To: Town of Cottage Plan Commission

FROM: Mark Roffers, Town Planner

DATE: November 19, 2025

RE: Skaar Pit (Huston) Business Park Rezoning, Preliminary Plat, Certified Survey Map (CSM)

CONCEPTUAL RURAL BUSINESS PARK DEVELOPMENT PLAN
HIGHWAYS 12/18/N INTERCHANGE—NORTHEAST QUADRANT
TOWN OF COTTAGE GROVE COMPREHENSIVE PLAN
DANE COUNTY, WISCONSIN

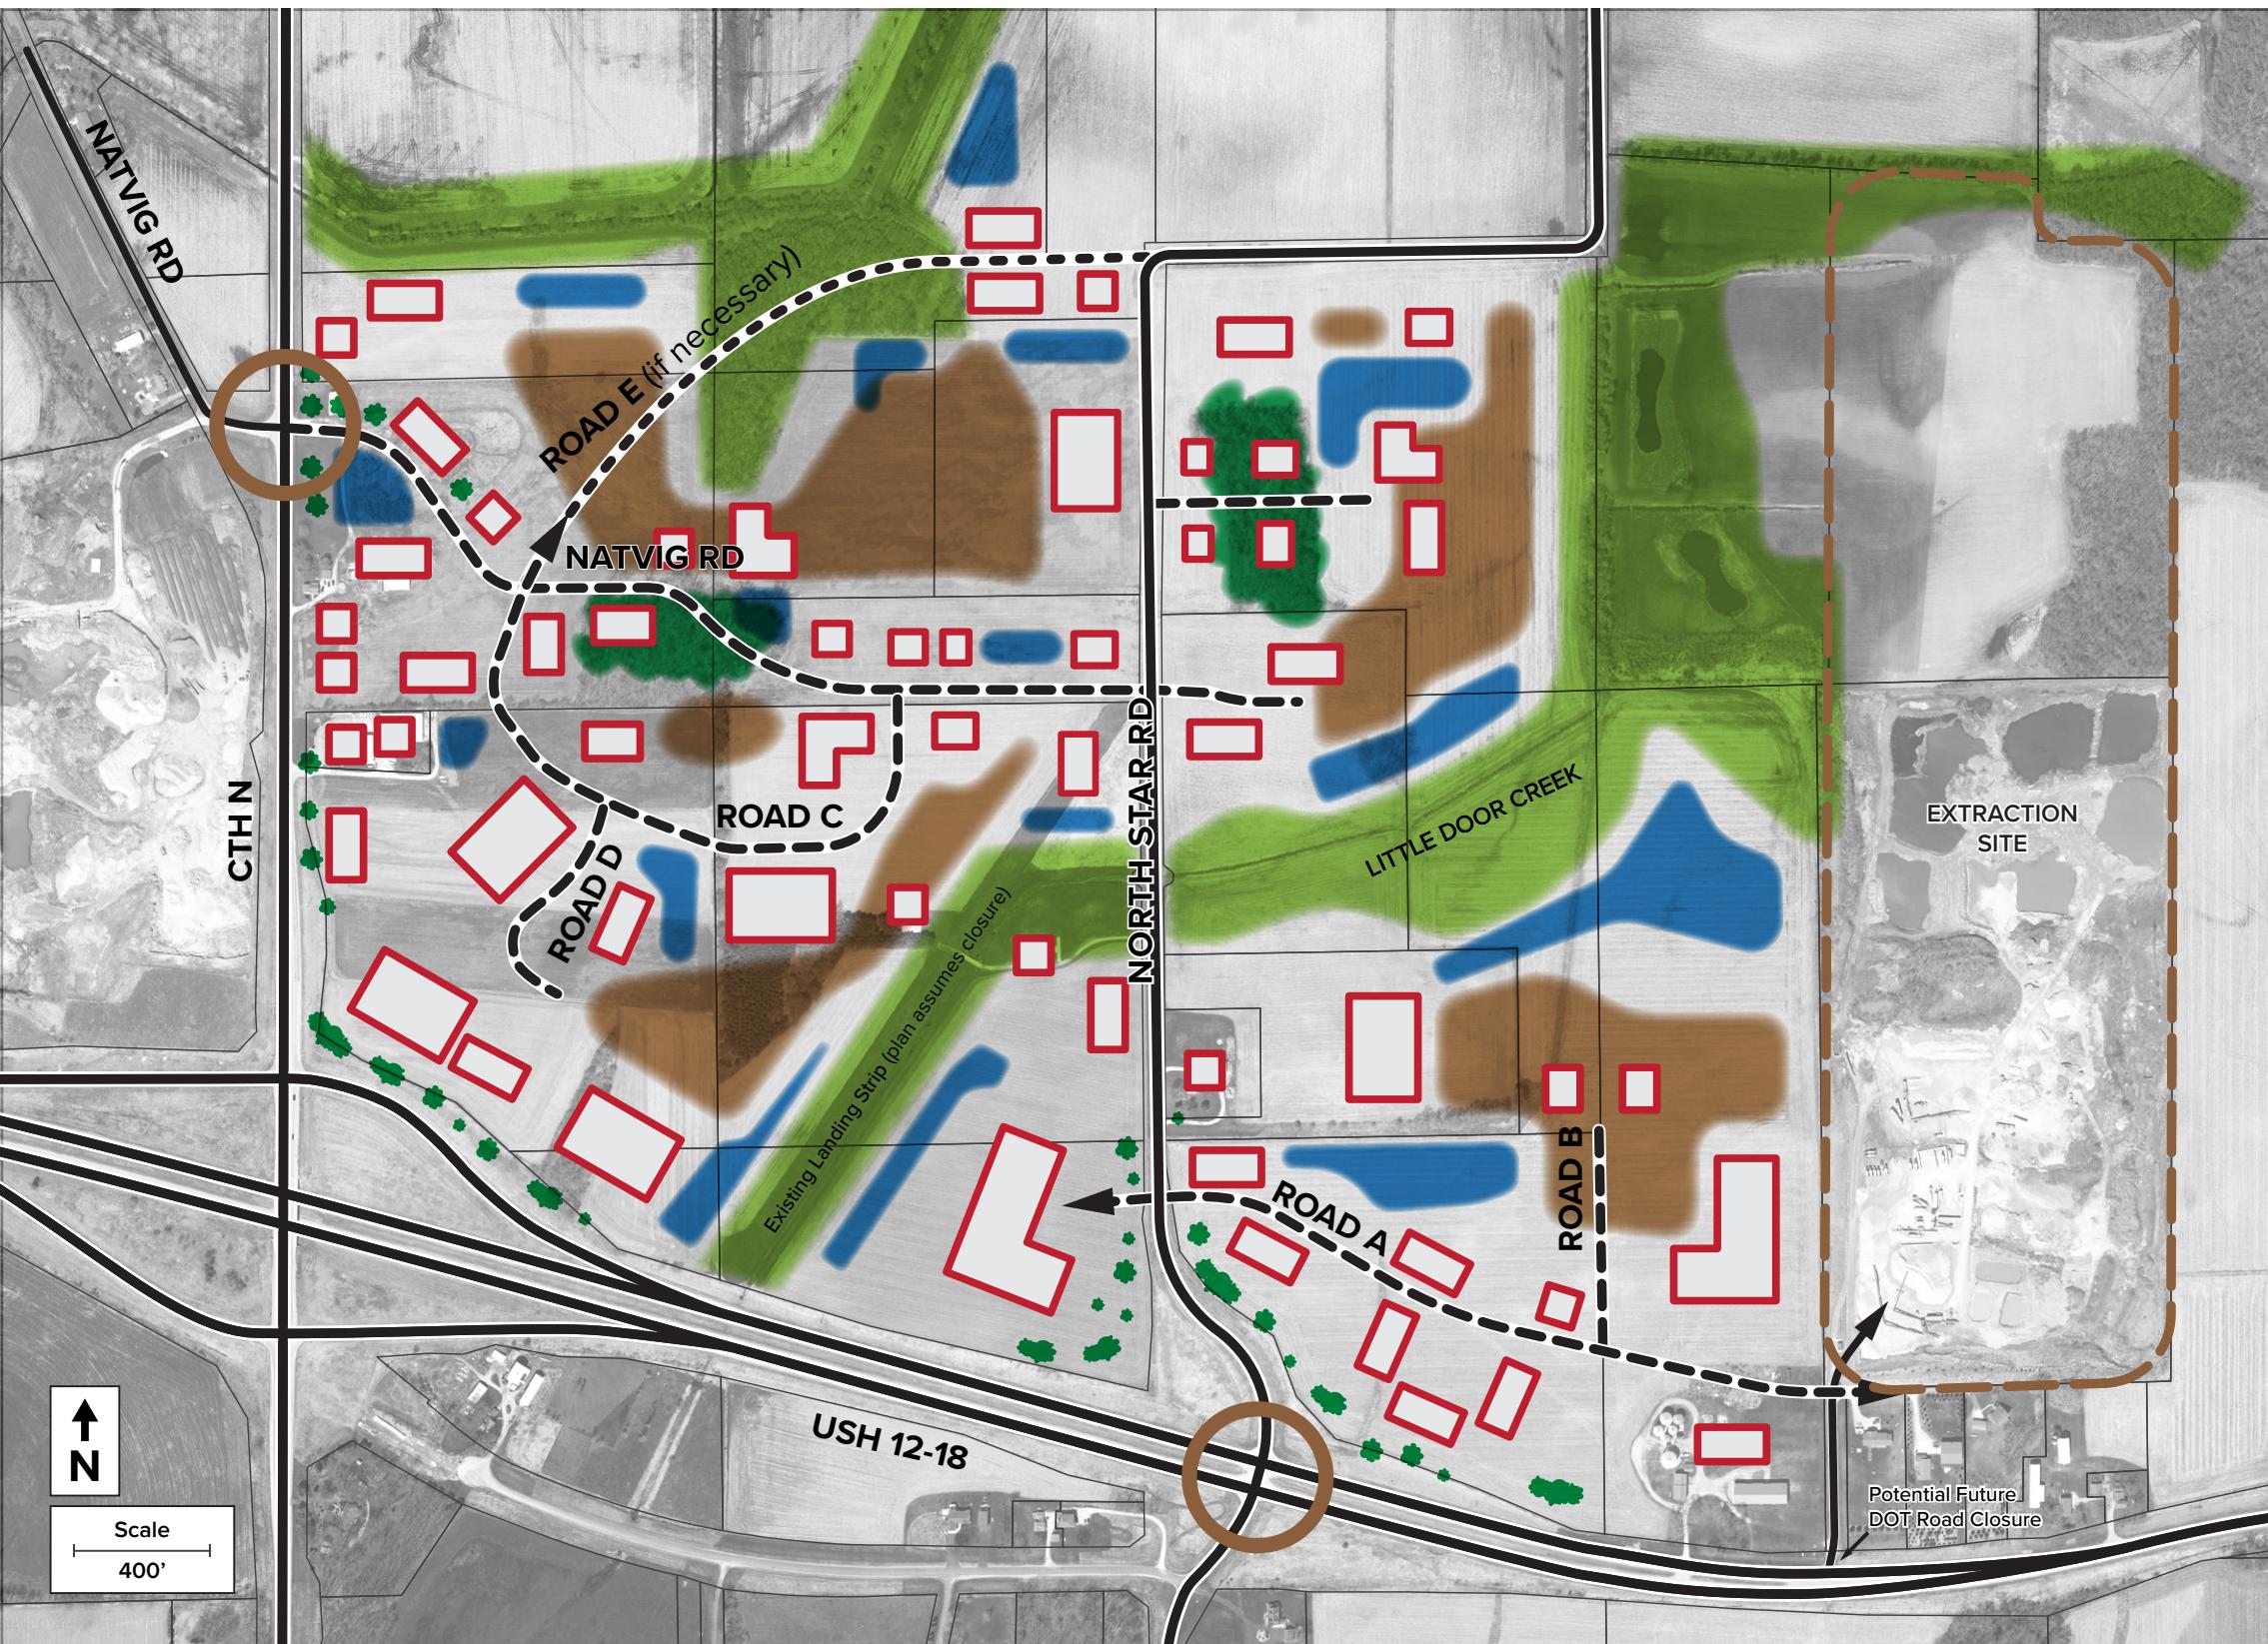
- a. Figure 9 of the Comprehensive Plan suggests land uses "that emphasize storage (particularly outdoor storage) and outdoor display and activities should be minimized." Per the attached Plan map, some more interior parts of this proposed development are indicated as acceptable for larger outdoor storage yards (brown) due to lower highway visibility. The applicant has proposed the attached deed restrictions to address impacts associated with outdoor activities, including that outdoor *storage* would require a conditional use permit, could not be located within 200 feet of any highway, would be screened from all streets and highways, and cannot be the sole use without a building.

- e. The Town Plan also suggests potential for a secondary road connection to the northeast (labeled “ROAD E (if necessary)” on attached map) to connect at the northern “bend” of North Star Road, through parcel 071128482510 (Larry Skaar). Referring to features shown on the preliminary plat map, this potential road would have to weave among a wooded, steep sloped drumlin and a floodplain to its immediate north. As a second “N-to-North Star” road connection, it would also seem to have limited additional value for business marketing and success, traffic movement, and public safety. I advise this secondary road connection not be required.
